APPLICATION NO.	FILING DATE	FIRST NAMED INVENTOR	ATTORNEY DOCKET NO.	CONFIRMATION NO.
09/961,365	09/25/2001	Kazumasa Ayukawa	P21475	5941
7055	7590	05/11/2004	EXAMINER	
GREENBLUM & BERNSTEIN, P.L.C. 1950 ROLAND CLARKE PLACE RESTON, VA 20191			CHARLES, MARCUS	
			ART UNIT	PAPER NUMBER
			3682

Office Action Summary	Application No.	Applicant(s)
	09/961,365	AYUKAWA ET AL.
	Examiner Marcus Charles	Art Unit 3682

DETAILED ACTION

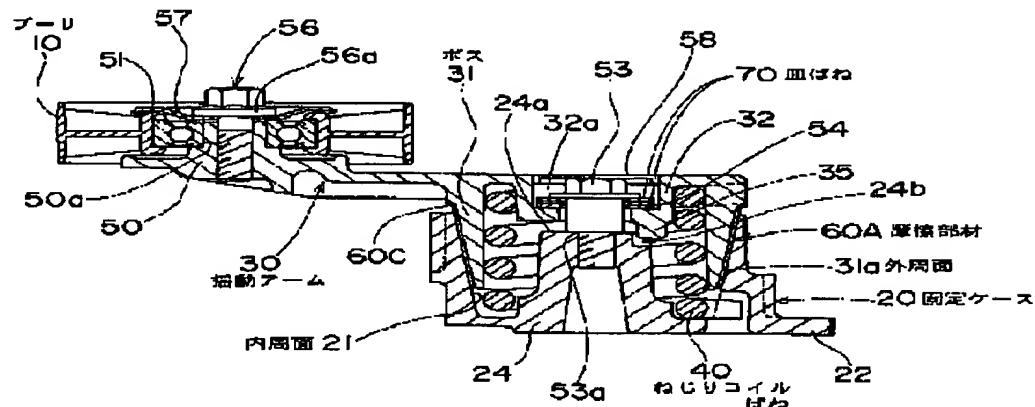
3. Claims 1-4 are rejected under 35 U.S.C. 103(a) as being unpatentable over JP (05-83516) in view of Katzab (4813,915). JP (05-83516, applicant's prior art) discloses a tensioner comprising a base (20) with a bottom having a tubular shape, a rocking arm (30) having a tubular part (31) rotatably supported inside the base, a pulley (10) attached to the rocking arm, a torsion spring (40) housed in the base and biases the rotation of the rocking arm to tension a belt, wherein the torsion spring is attached concentrically to the axial axis of the base and a friction member (60) interposed between the outer circumference of the tubular part (31) and the inner circumferential surface of the base (20). JP (05-83516 further disclose that the one end (see attached drawing) of the torsion coiled spring (40) is attached to the base and the other end is

attached to the arm. JP (05-83516) does not disclose that the torsion spring is attached eccentrically to the axial center of the base. Katzab (4813,915) discloses a tensioner with a base (10) arm having a tubular part (8) and an a torsion spring (33) attached eccentrically with the axial center of the base (figs. 5-6) in order to provide a greater biasing forcing in one direction. Therefore, it would have been obvious to one of ordinary skill in the art at the time of the invention to modify the tensioner of JP (05-83516) such that the torsion spring is attached eccentrically to the axial center of the base in view of Katzab in order to provide a greater biasing forcing in one direction. It is apparent that a first damping force acting on the arm when the belt is in tension is relatively larger than a second damping force acting on the arm when the belt is slack due to the eccentricity of the spring to the axial center

In claim 2, it is apparent that the rocking arm is removably attached to the base via the fastening assembly (35).

In claim 3, note the friction member (21) interposed between outer circumferential surface of the tubular part of the arm and the inner tubular part base member and the friction member is provided across a range of at least 180° around the axial center of the base.

In claim 4, note the projections (61) provided on the friction member.

[1]

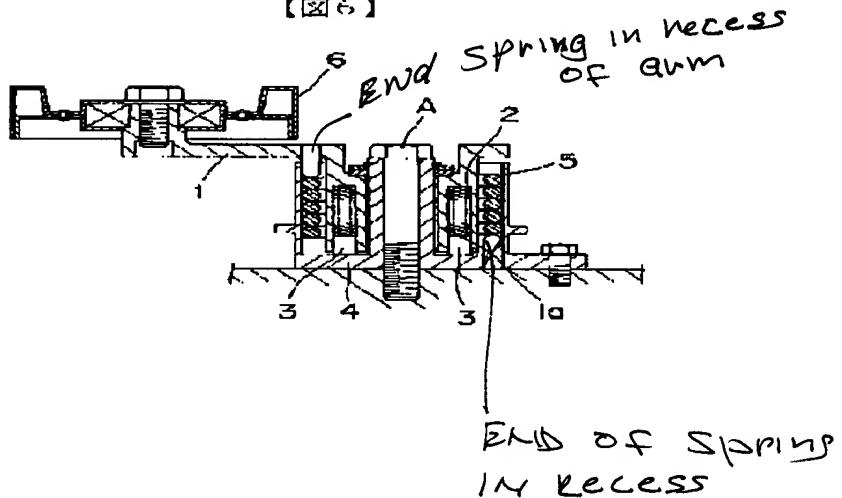
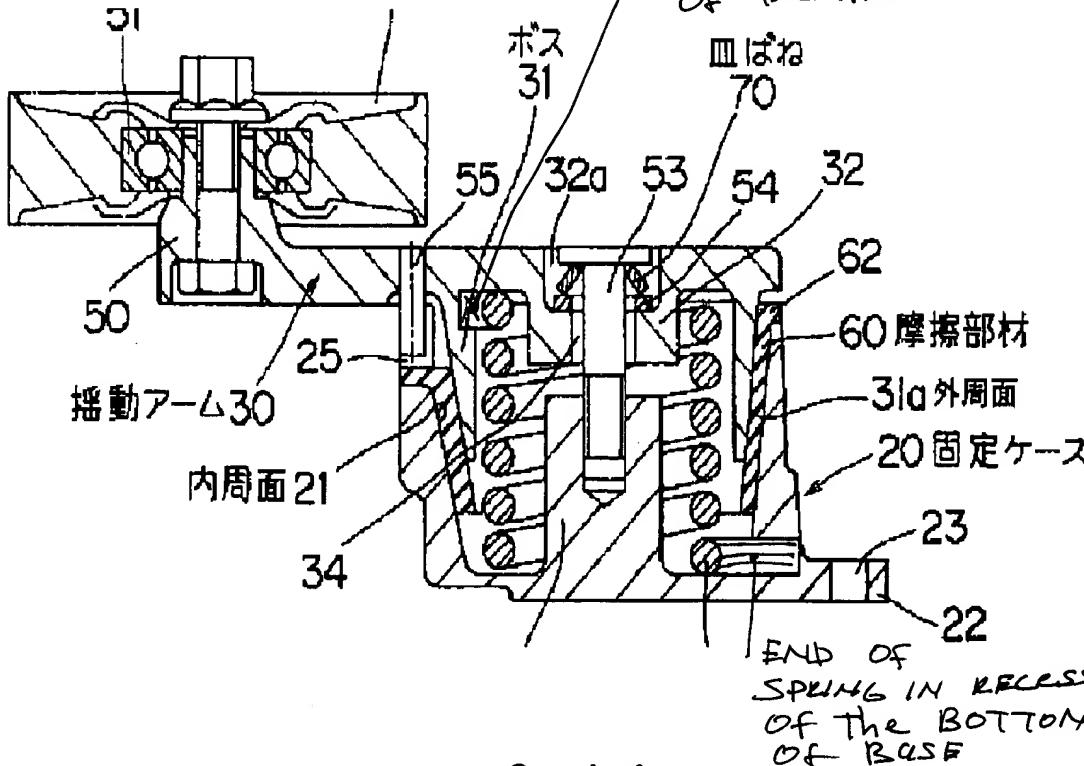
5. Applicant's arguments filed 03-06-2004 have been fully considered but they are not persuasive. Applicant's arguments with respect to claims 1-4 have been considered but are moot in view of the new ground(s) of rejection. Applicant contended that the prior art fails to disclose the torsion coiled spring includes one end that is connected to the base by a recess formed in the bottom of the base and an other end connected to the arm by a recess formed in the bottom of the arm. In response, the new limitation of the amended claim broadly claimed that one end of the coil spring is attached to the base and another end is connected to the rocking arm. As disclosed in the rejection, JP 05-83516) clearly meet the claimed limitation. Figures 1-6, of JP 05-83516) shows the ends of the spring connected to the arm and the base respectively.
